Project No. 2021\_154

MIDLOTHIAN ISD STADIUM ADDITIONS AND RENOVATIONS

ADDENDUM NO. 2

DATE: October 18, 2021

4 CMU WALL SECTION - EAST  
3/4" = 1'-0" REF 1 / A-101

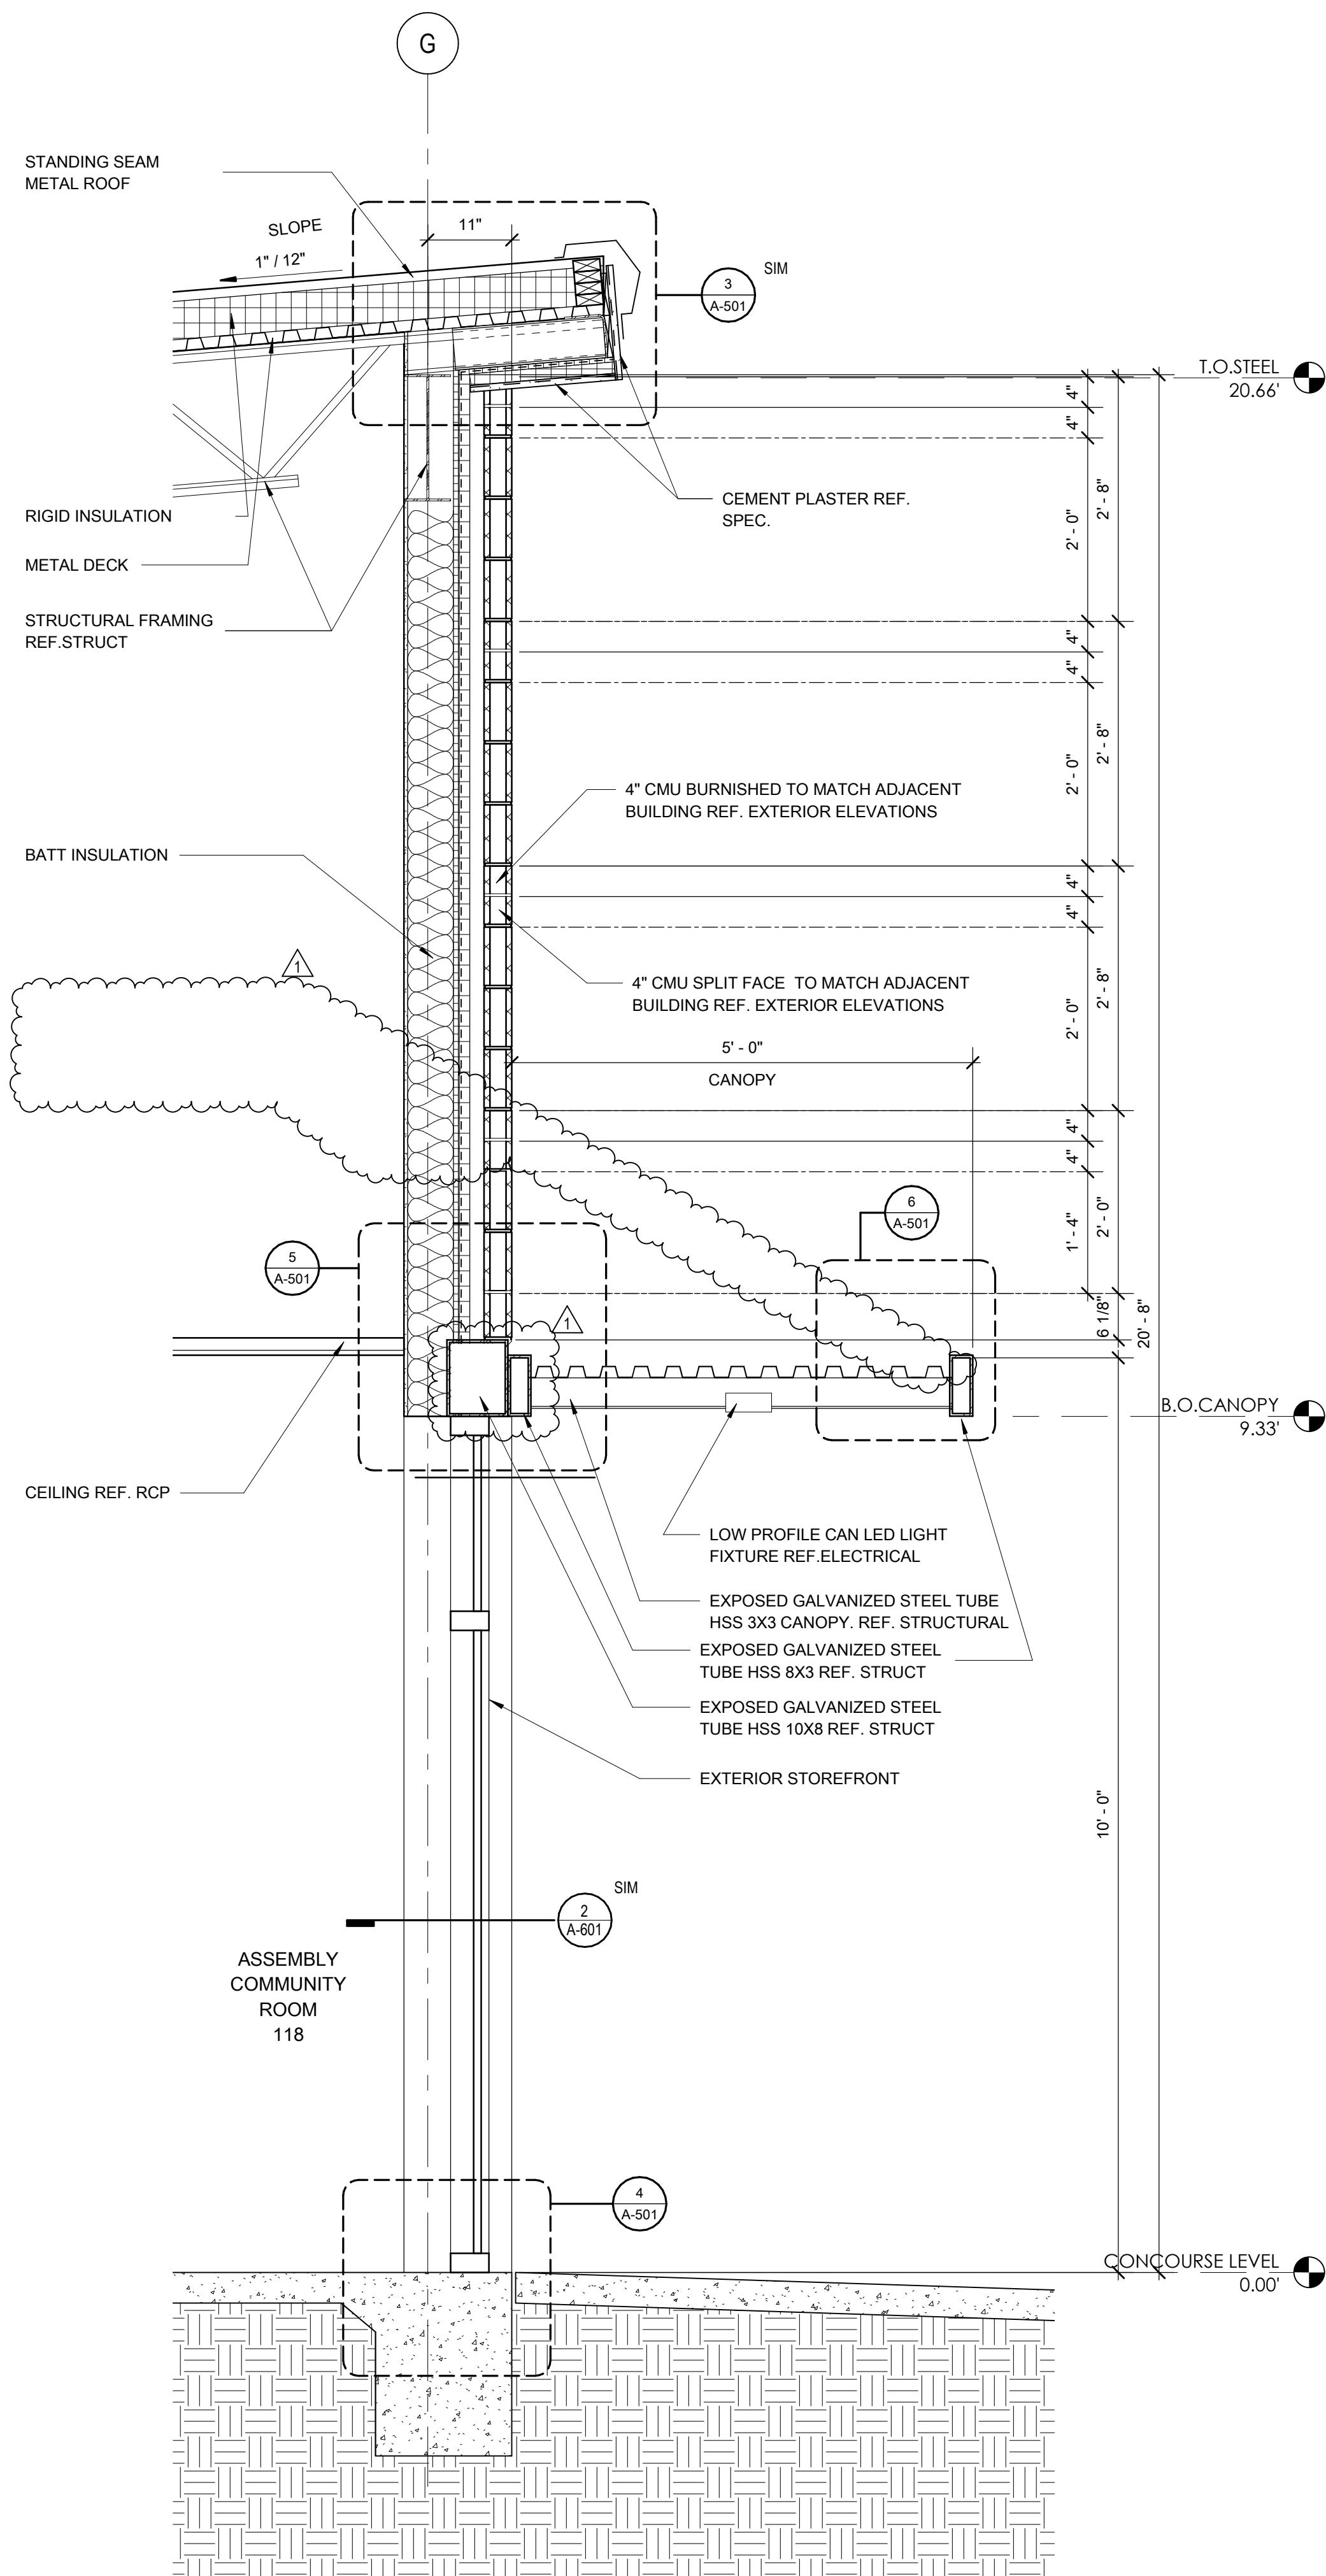
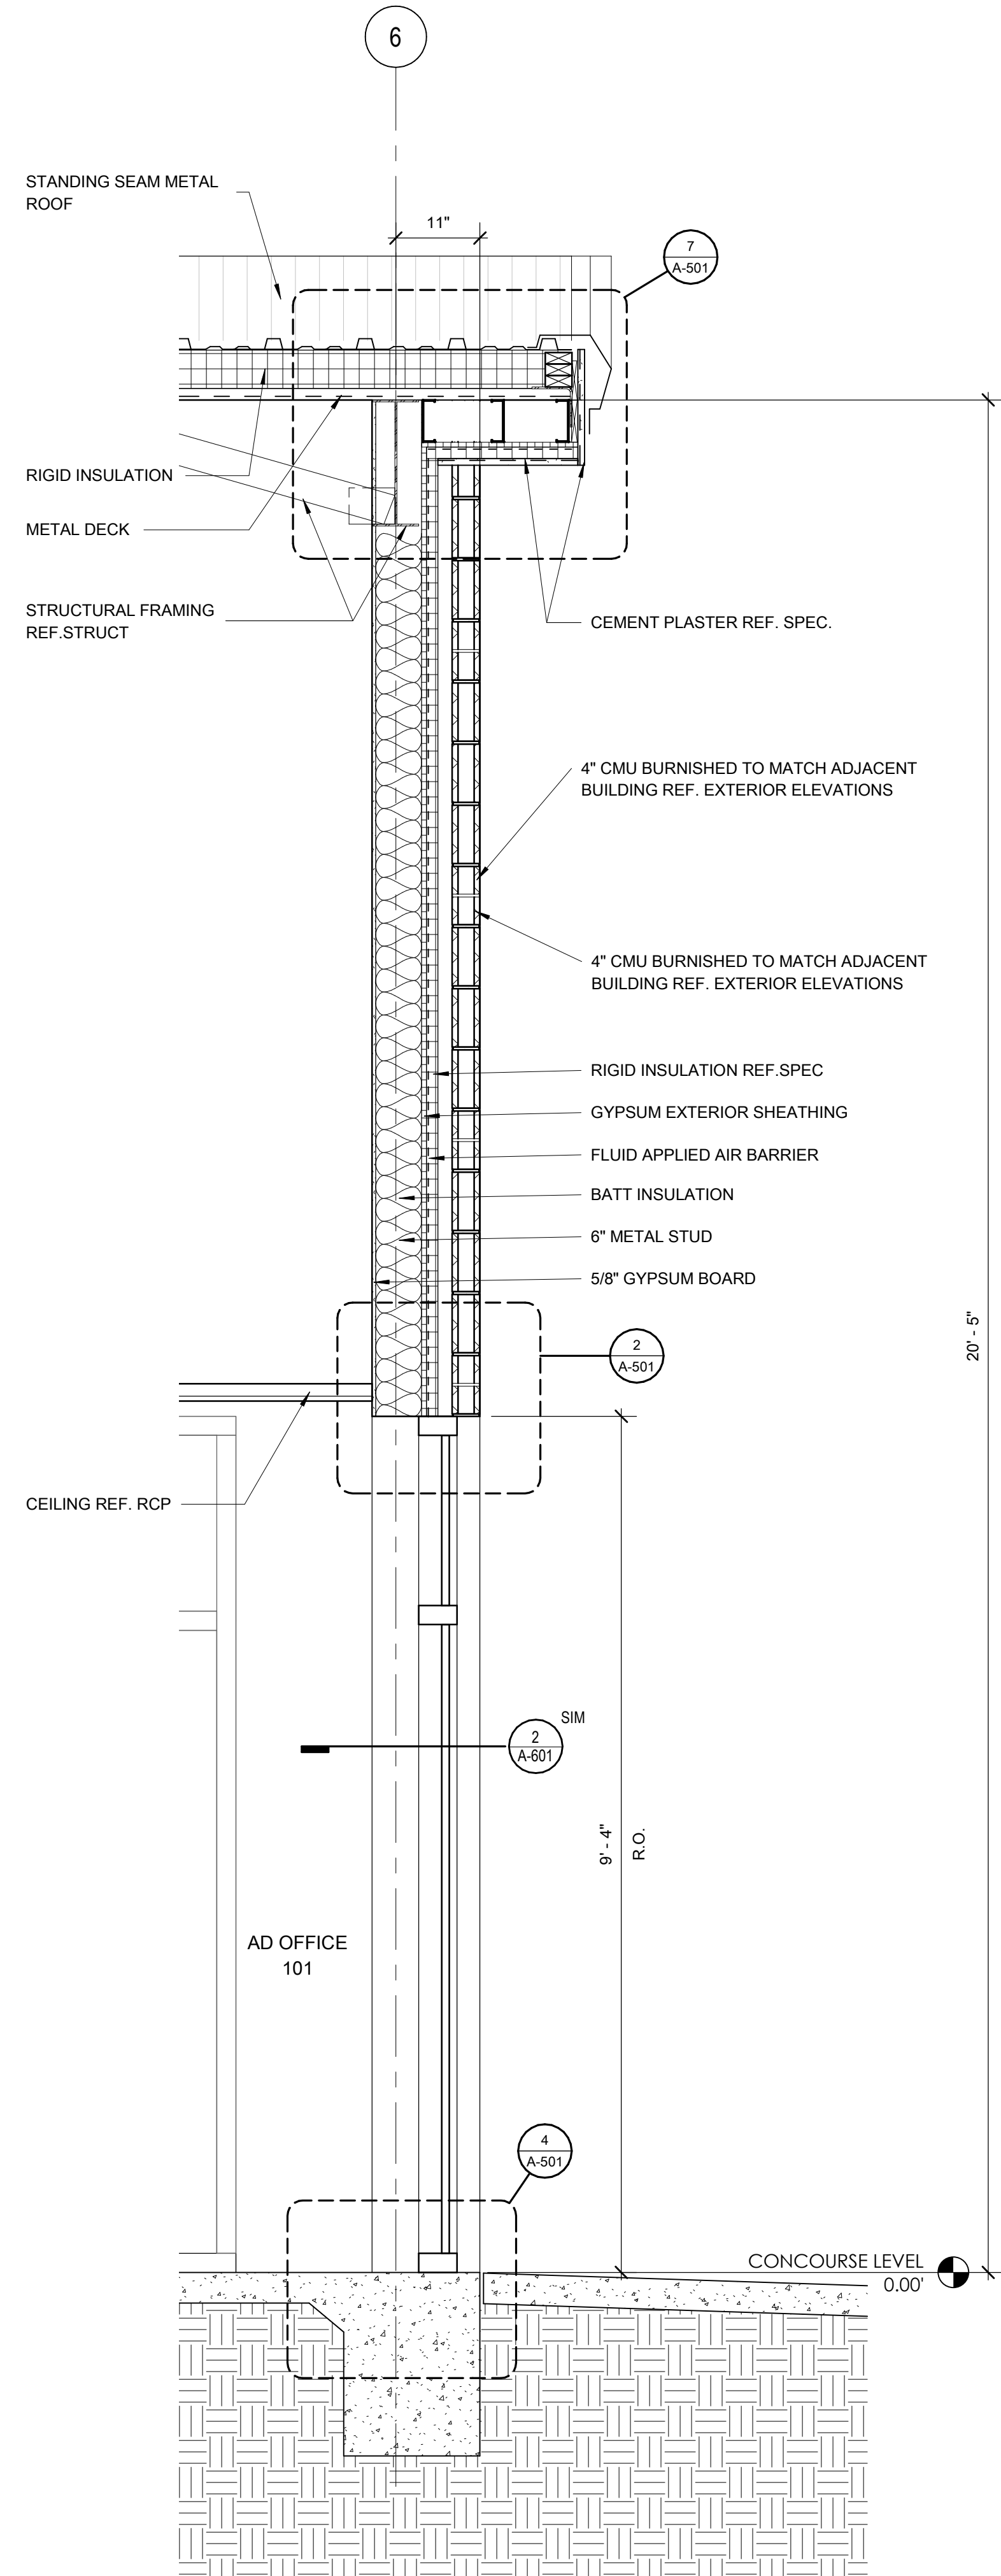
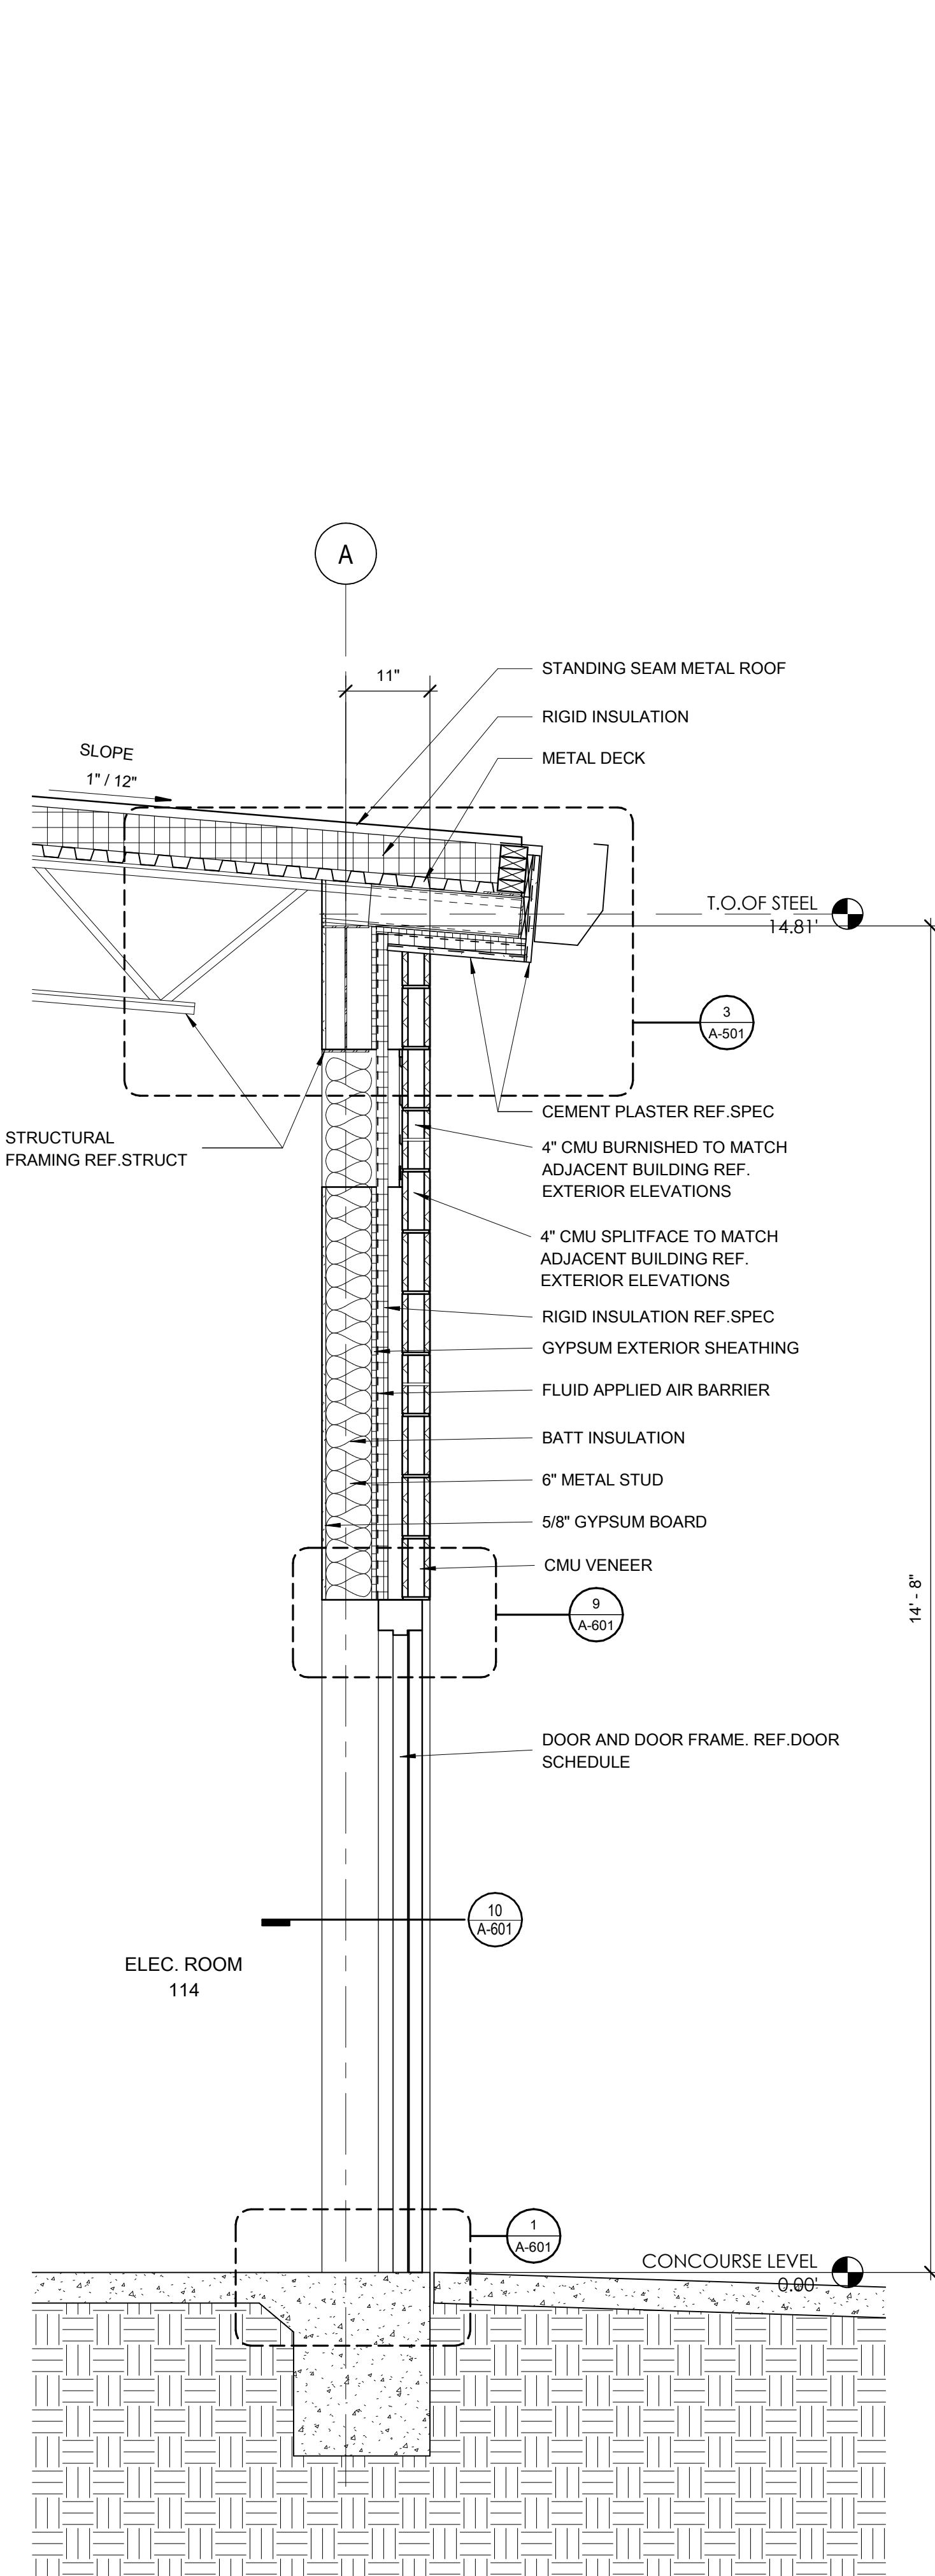
- A2.13 SHEET A-303 – WALL SECTIONS:  
REMOVE and REPLACE in its entirety.  
a. REMOVE steel tie backs
- A2.14 SHEET A-402 ENLARGED PLANS, INTERIOR ELEVATION, CASEWORK DETAILS:  
REMOVE and REPLACE in its entirety.
